**Chemung County Stormwater
Construction Inspection
Erosion and Sediment Control**

| Project Name Dollar General Southport | Date 12-11-19 |

PROJECT: Dollar General Southport
Town of Southport
Municipal Inspection
December 11, 2019

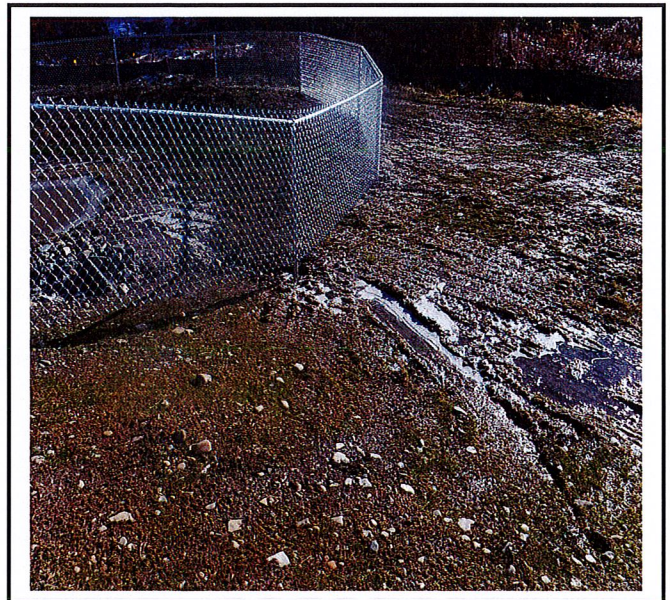
Trash and debris in the pond.

Area where wetland plants are supposed to be planted.

Roof leaders are still not connected to the tree planter box. Erosion is occurring on the end closest to the stormwater basin.

Area not de-compacted, topsoiled or in good condition.
